5.1. NEGOTIATED DECISION LOT RECONFIGURATION 12-36 ALCHERA DRIVE MOSSMAN

REPORT AUTHOR(S)	Simon Clarke, Planning Coordinator
GENERAL MANAGER	Nick Wellwood, General Manager Operations
DEPARTMENT	Development Assessment and Coordination
PROPOSAL	Reconfiguring a Lot (1 Lot into 67 Lots and Balance)
APPLICANT	Maxholl Pty Ltd C/- Brazier Motti Pty Ltd PO Box 1185 CAIRNS QLD 4870
LOCATION OF SITE	12-36 Alchera Drive MOSSMAN
PROPERTY	Lot 113 on SP213765

EXECUTIVE SUMMARY

1. Negotiated Decision Notice Amended Approved Plan **[5.1.1]**
2. Original Approved Plan with Unsatisfactory Park Configuration **[5.1.2]**

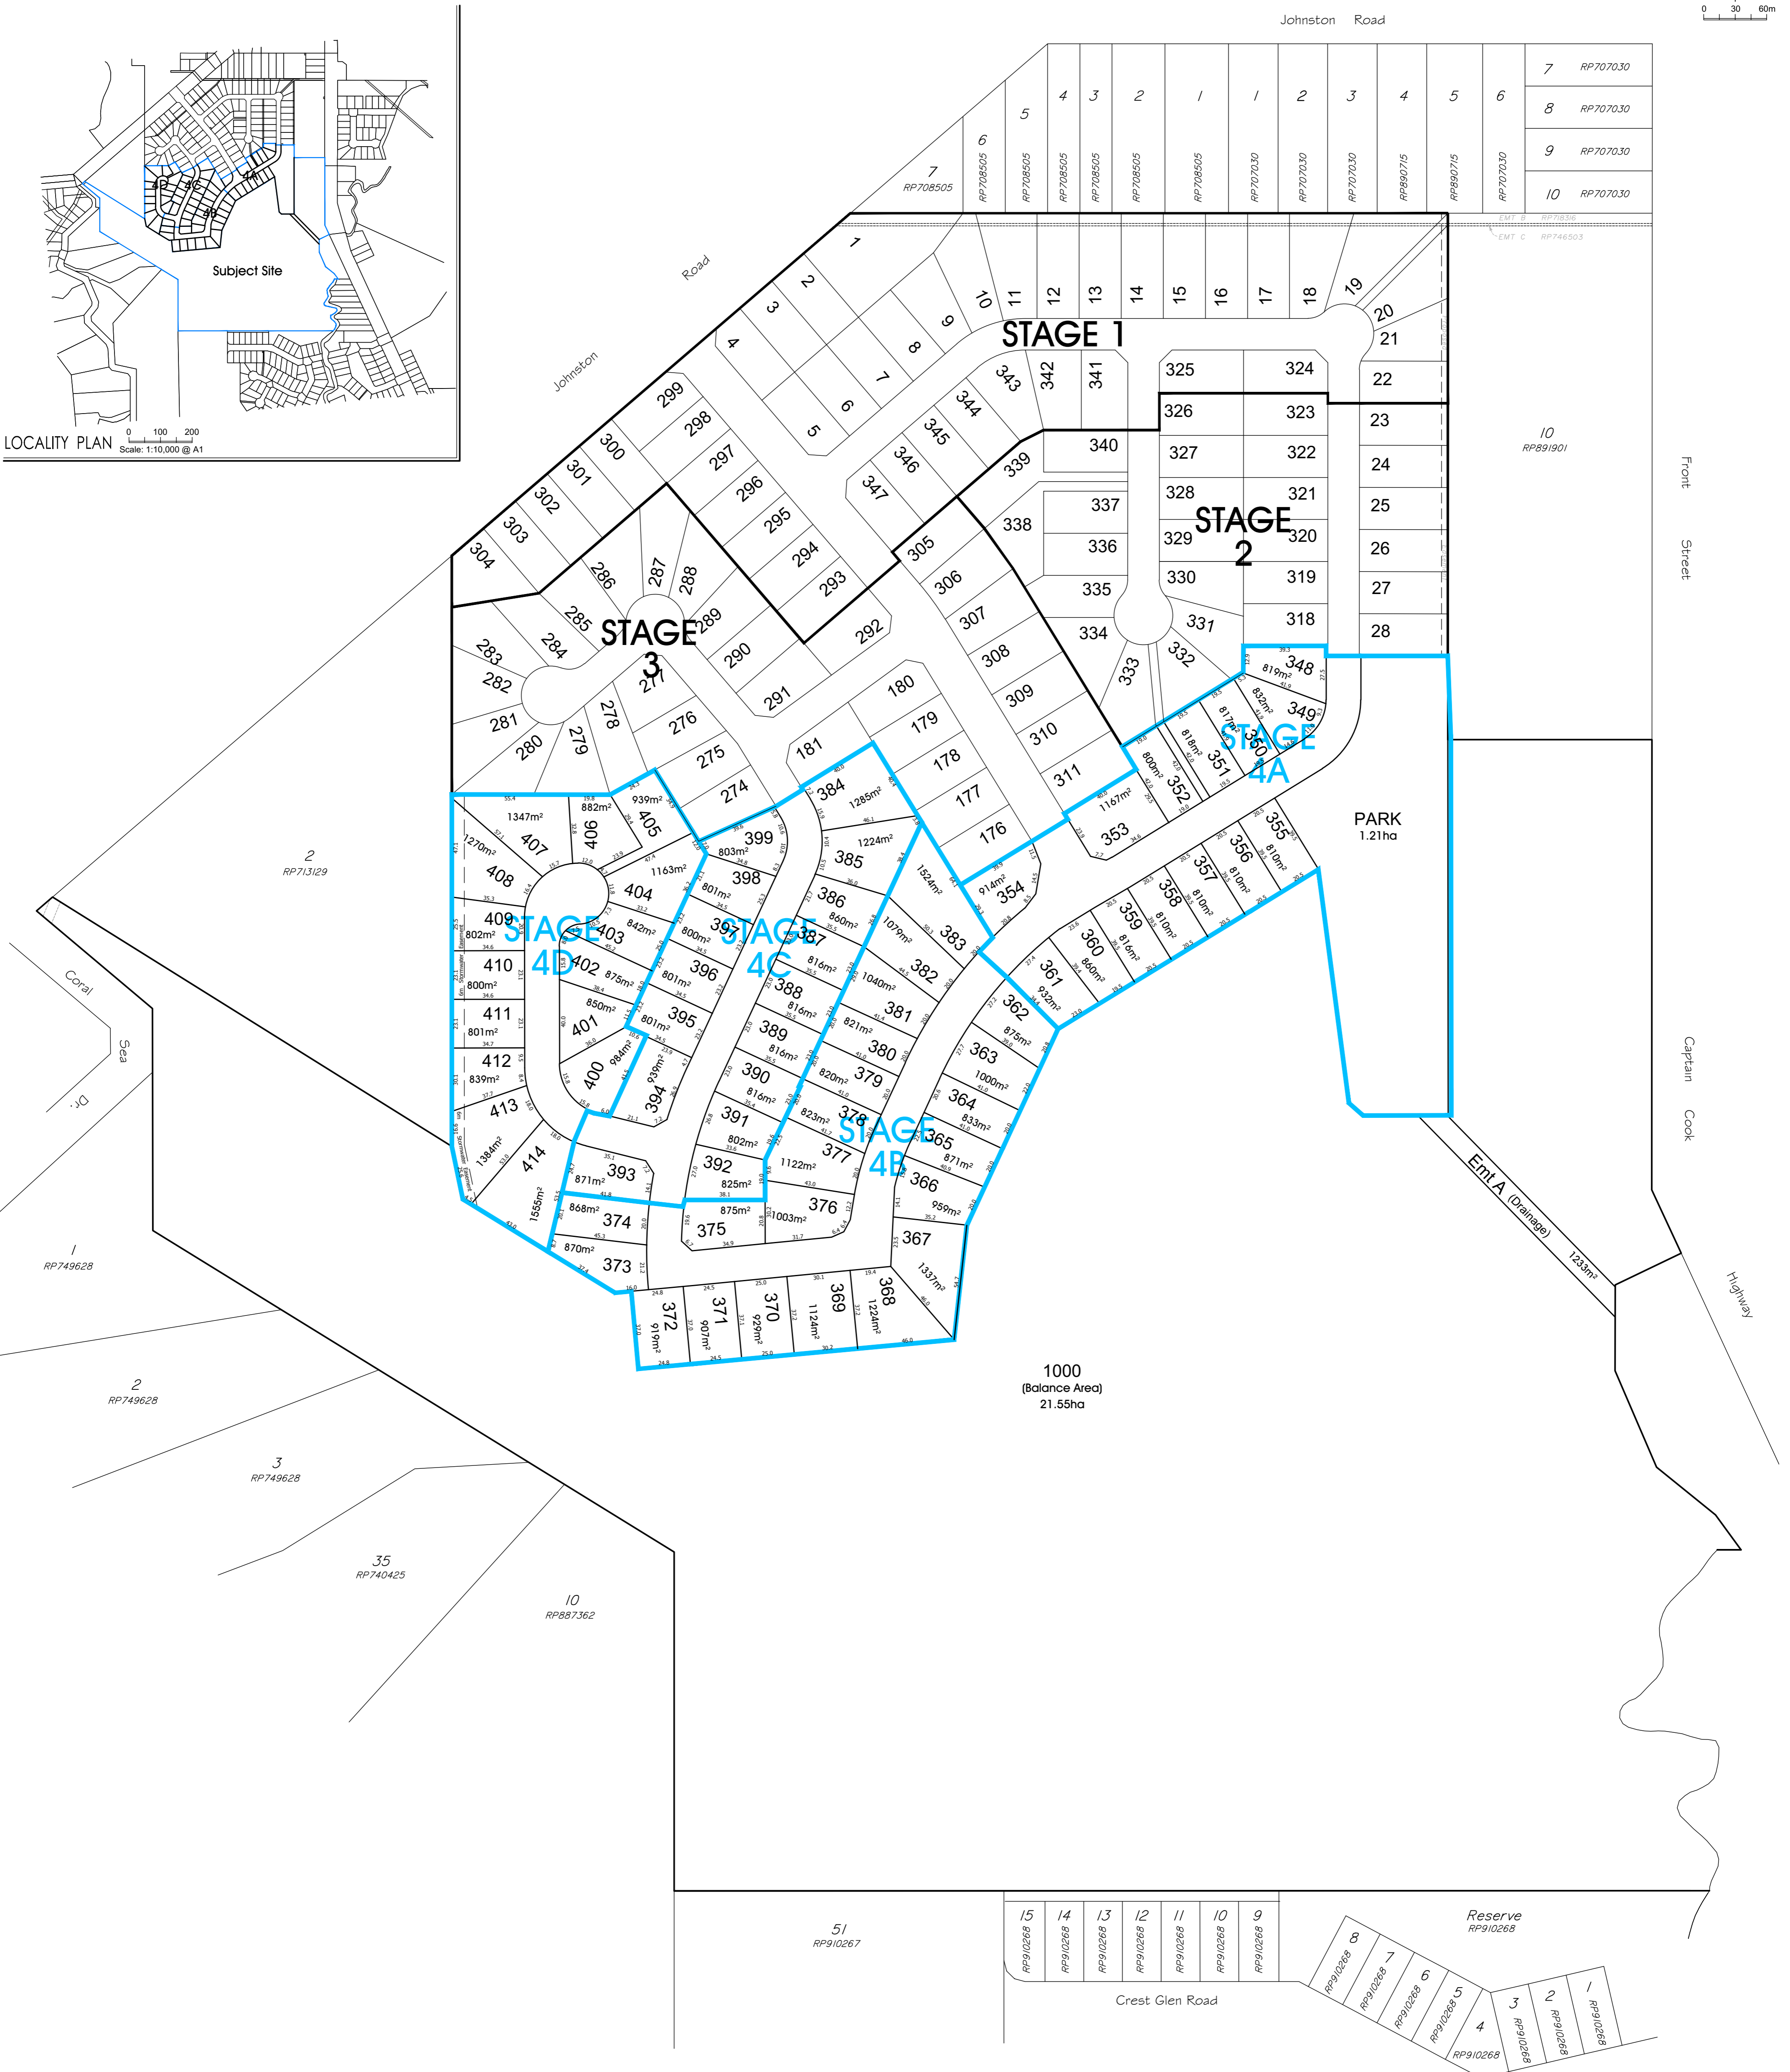
The proposed lot reconfiguration plan has been amended to revise the location of the park. As shown on the amended plan (Brazier Motti Drawing 31122/121A dated 1 March 2017) the park has been centrally located in line with Council's expectations.

Comments: The amended plan meets Council's expectations with respect to the parkland location. It is further recommended that a note be placed at the end of condition 10 to acknowledge that the provision of park in Stage 5 is only in partial compliance with respect to the overall parkland contribution required for the ultimate development.

Condition 4(a) and 4(b) identify the amendments that are required to the lot reconfiguration plan. The plan has been amended to substantially address the requirements contained within the amendment and the conditions can be deleted.

Comments: The amended plan does substantially address the amended requirements contained in the condition. However, condition 4(a) contains a requirement to ensure that the extension to Daintree Horizons Drive is designed to be suitable for buses in accordance with the FNQROC Development Manual. It is recommended that this requirement be retained in an amended condition 4.
